Subject Change Order No. 1 Agreement Between Owner and Contractor CWS Construction Group, Inc.- Castlemont High School Field and Bleachers Replacement Project- Division of Facilities Planning and Management

CHANGE ORDER NO. 01

PROJECT: Field & Bleachers Replacement Project
Castlemont High School

PROJECT	Castlemont HS Field & Bleachers
CPS JOB NO.	22-125
CLIENT	
DATE ISSUED	Wednesday, August 31, 2022
REFERENCE NO.	
SPEC SECTION	
DRAWING NO.	MP2.1
ATTACHMENTS	
SCHEDULE IMPACT	
COST IMPACT

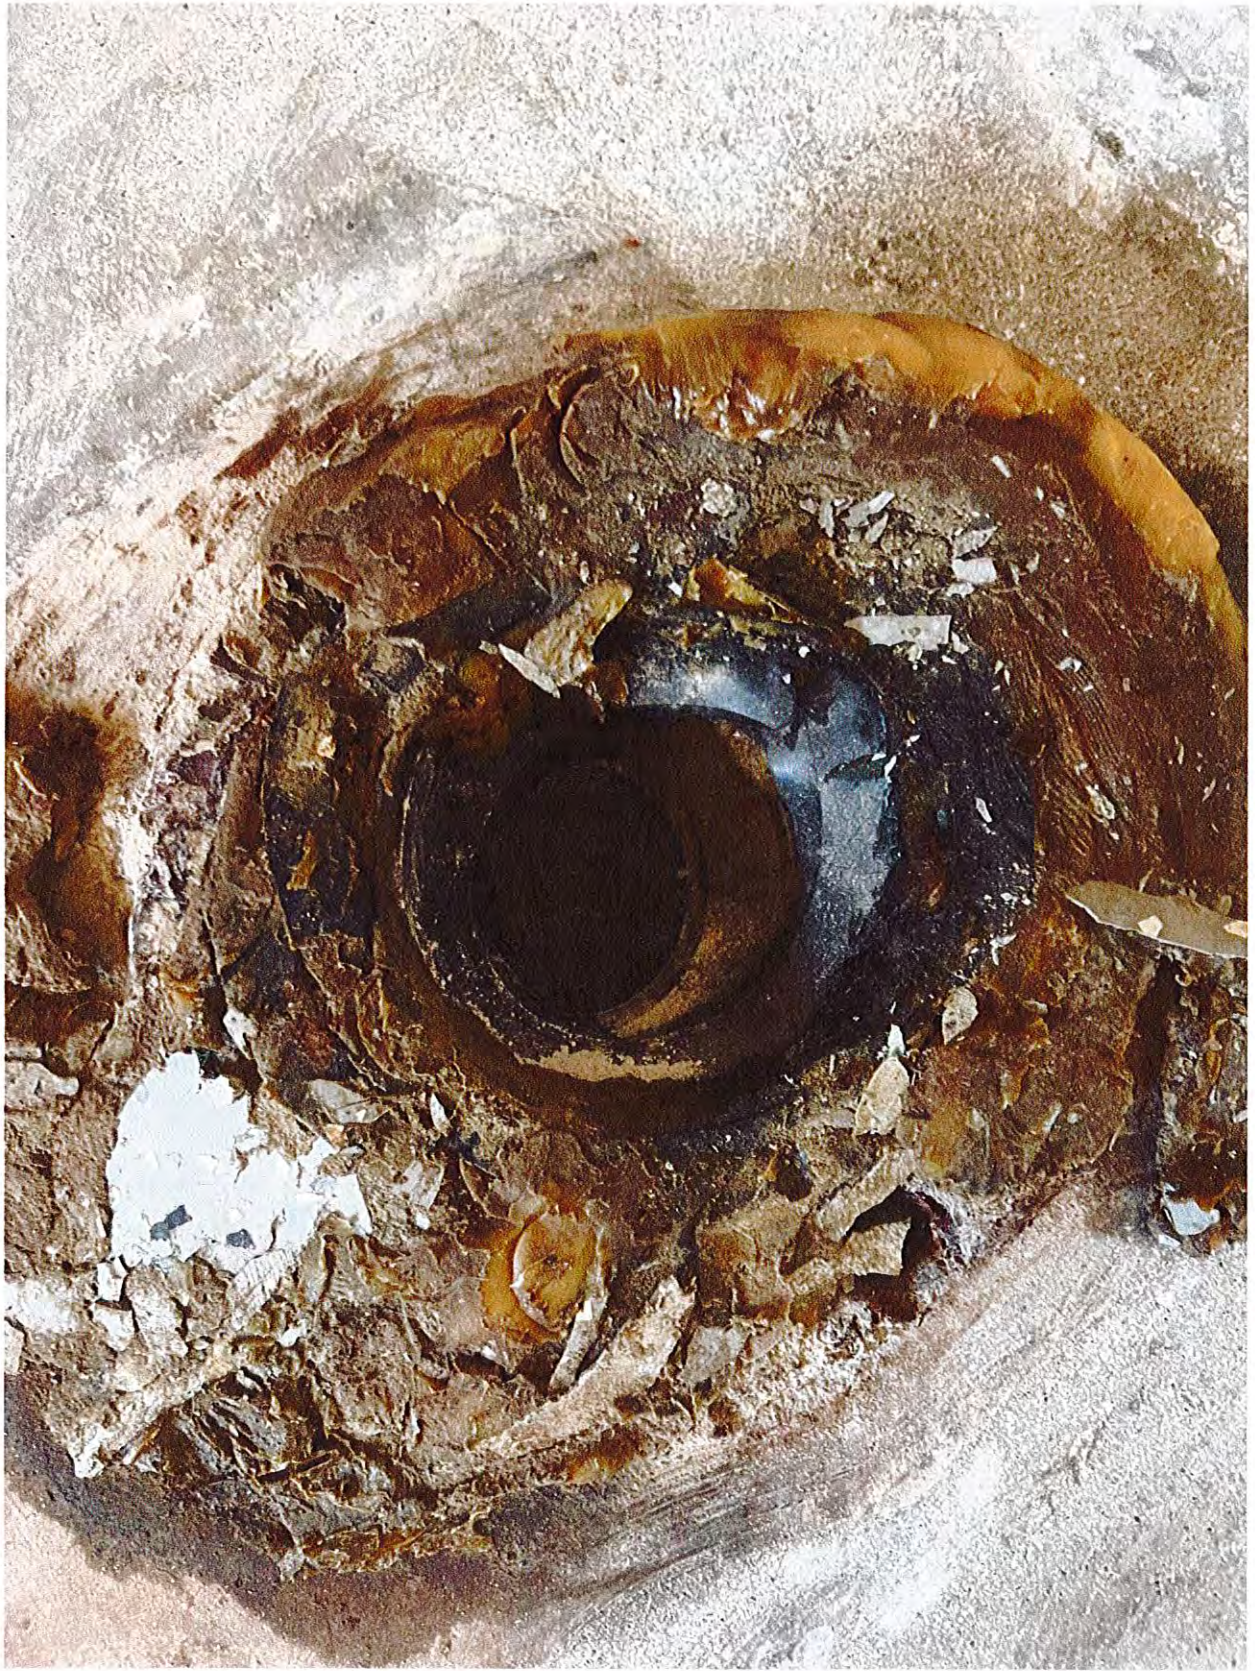
Existing North and South Restrooms. Existing toilet flanges are not in re-usable condition. Concrete needs to be sawcut and chipped out to replace the flanges. See attached photos and provide directions. (All flanges are in similar condition)

DESCRIPTION OF PROPOSED CHANGES IN WORK (specifically refer to attached pages or incorporated documents): Replacing the existing toilet closet flanges in north and south restrooms per approved RFI #039.

Attachments: Drawings A2.2, A4.0, E1.2 & E3.2, dated 9/29/22 Delta 6

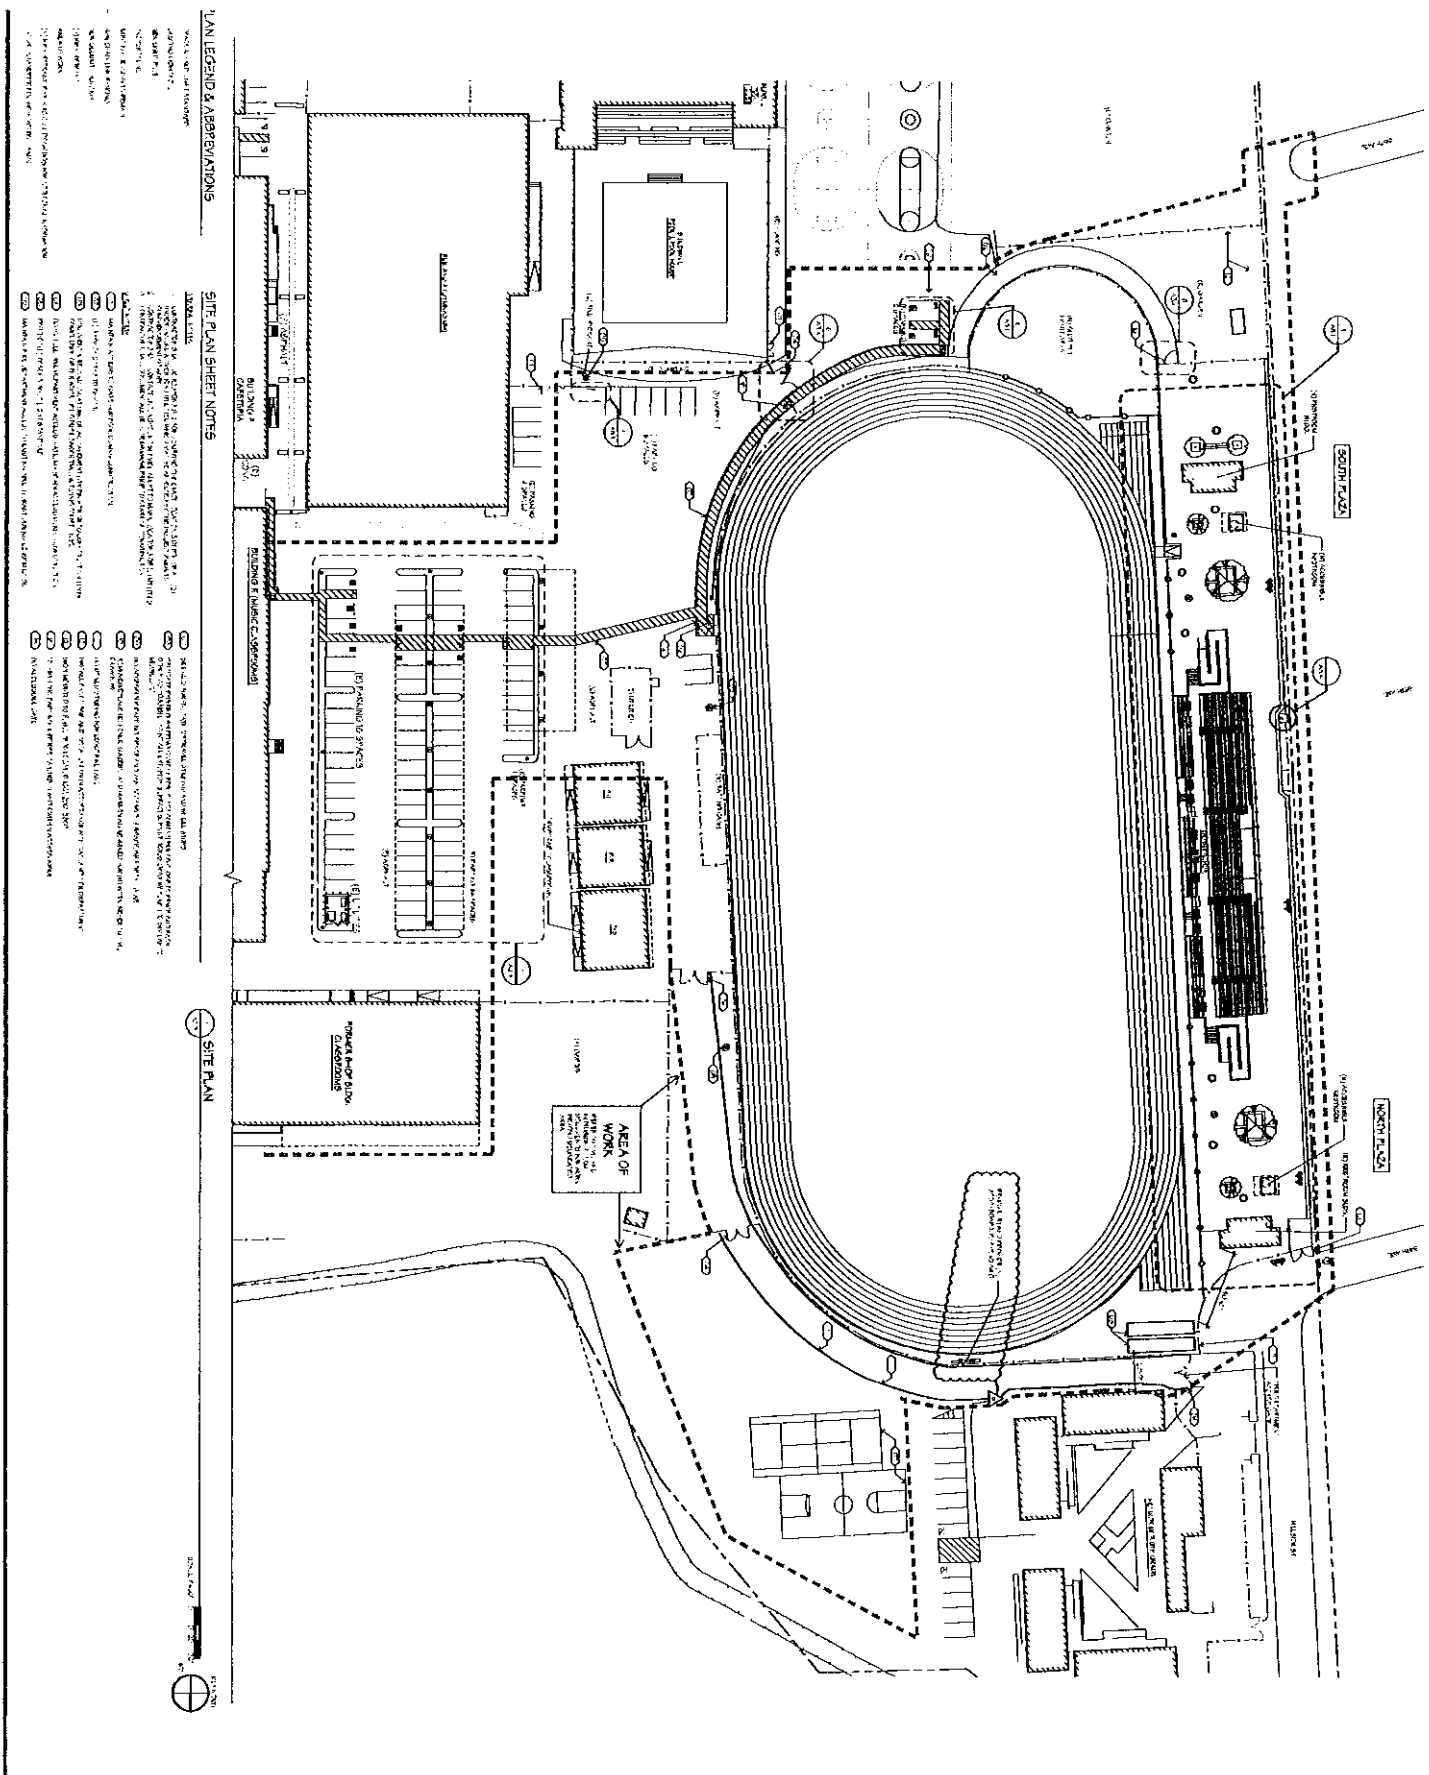
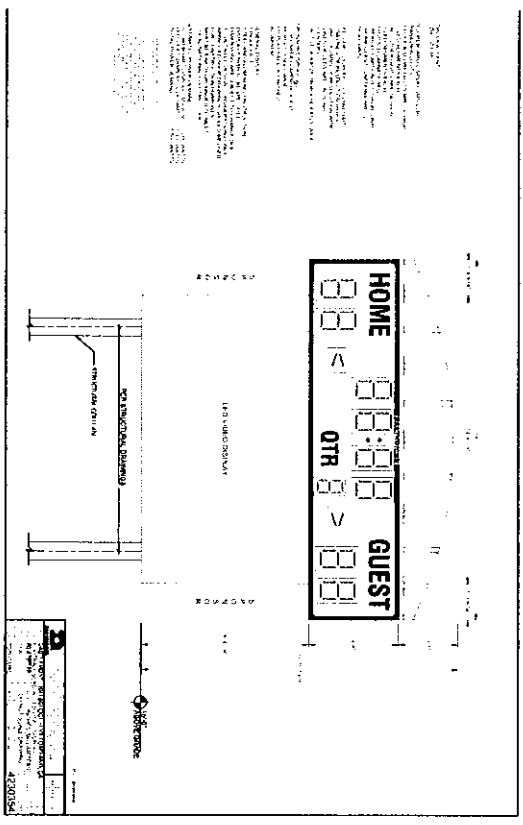
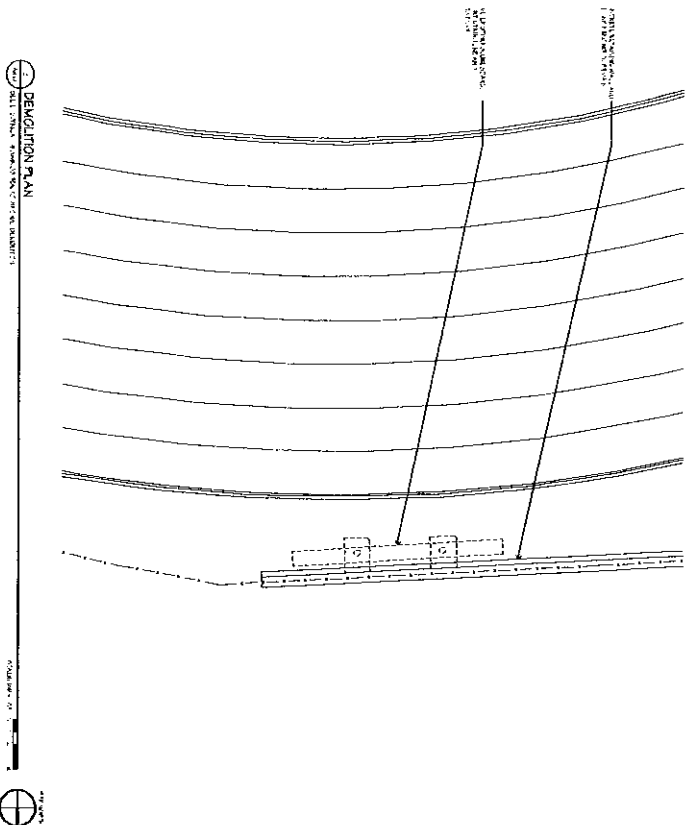
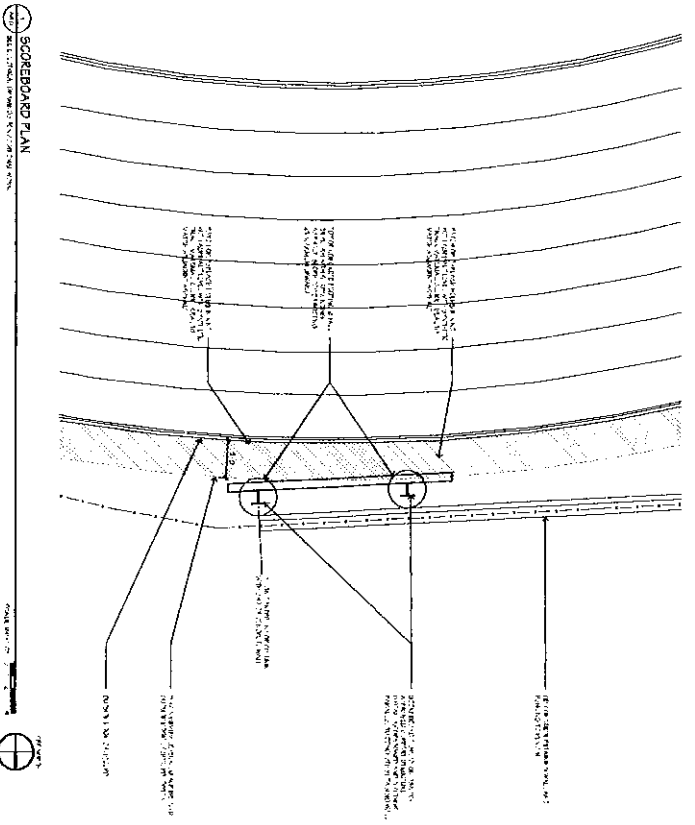
Description of Changes: Remove existing scoreboard, columns, footings, and utilities not to be reused. Provide design, structural engineering and installation of new Daktronics scoreboard with structural columns, footings, pavement and utilities, etc. for a complete installation. Scoreboard design and structural engineering of columns and footings, etc. shall be sufficient for submittal to DSA for review and approval.

Reason: Owner decision to replace scoreboard
